# UNITED STATES PATENT AND TRADEMARK OFFICE

<b>Office Action Summary</b>	<b>Application No.</b> 10/812,011	<b>Applicant(s)</b> LIM, JEONG-SU	
	<b>Examiner</b> Todd M. Epps	<b>Art Unit</b> 3632

This is the second Office Action **final** for serial number 10/812,011, Monitor Apparatus, filed on March 30, 2004.

FIG. 1  
(PRIOR ART)

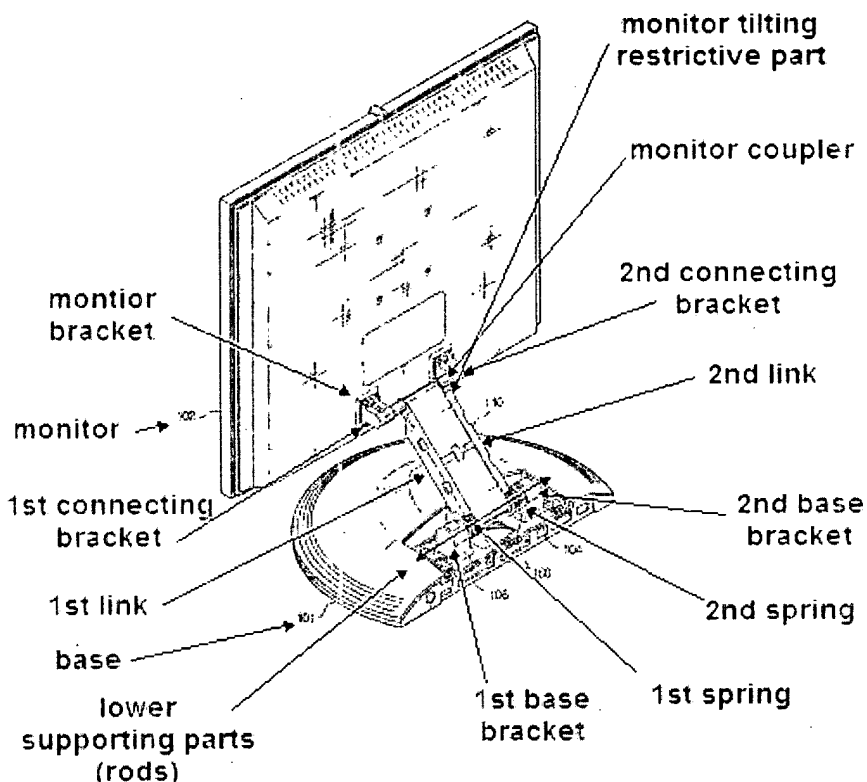
The prior art discloses a first link (110, 1<sup>st</sup> side) provided between the monitor (102) and the base (101); a second link (110, 2<sup>nd</sup> side) provided between the monitor (102) and the base (101), and adjacent to the first link; a base bracket (104, and 106), combined to the base (101), the base bracket having first and second lower supporting parts (adjacent of 104, and 106) to rotatably support lower parts of the first and second links, respectively; a connecting bracket (fig. 1) rotatably combined to the monitor (102), the connecting bracket having first and second upper supporters (fig. 1) to rotatably support upper parts of the first and second links, respectively; a first spring (fig. 1- 1<sup>st</sup> side) interposed between the first link and the first lower supporting part, to elastically bias the first link upward with respect to the base; a second spring (fig. 1- 2<sup>nd</sup> side) interposed between the second link and the second lower supporting part to elastically

bias the second link upward with respect to the base, wherein the distance between rotating axes of the first and second lower supporting parts that rotatably support the first and second links, respectively, is greater than the distance between tilting axes of the first and second upper supporters; a monitor coupler (fig. 1) spaced from the first and second supporters, and rotatably combined to the monitor; a link rotation restrictive part (fig. 1; bottom between springs and links) to restrict a rotation angle of at least one of the first and second links relative to the base; wherein a link rotation restrictive part further comprises a protrusion protruding from the base bracket to restrict the rotation angle of at least one of the first and second links by making contact with an upper surface of at least one of the first and second links (fig. 1); wherein the first spring further comprises a torsion spring having a first end coupled to the first lower supporting part, and a second end coupled to the first link; wherein the second spring further comprises a torsion spring having a first end removably coupled to the second lower supporting part, and a second end removably coupled to the second link; a monitor bracket (fig. 1 – backside of the monitor) combined to the monitor, and rotatably combined to the connecting bracket; a monitor tilting restrictive part (110 - top portion) to restrict a tilting angle of the monitor bracket relative to the connecting bracket; and a projection protruding from the monitor coupler, and a stopping part (fig. 1) formed by cutting an arc of the connecting supporter provided in the monitor bracket; wherein height of the monitor is adjusted by rotating the first and second links relative to the base (fig. 1-2B);

In response to applicant's argument that the "Description of the Related Art" (fig. 1) does not disclose a connecting bracket rotatably combined to the monitor. The Examiner clearly disagrees. With reference to the office action above and the drawing below, the applicant will see that the above reference does in fact teach wherein a connecting bracket rotatably combined to the monitor. The figure shows the connecting bracket rotatably combined to the monitor as the monitor moves.

Furthermore, applicant argues that the "Description of the Related Art" does not disclose a base bracket having first and second lower supporting parts to rotatably support lower parts of the first and second links, respectively. The Examiner clearly disagrees. The Examiner recognized that there are rods or pivot parts on both ends from the base brackets through the springs and attached to both lower links. The rods are being used as support lower parts.
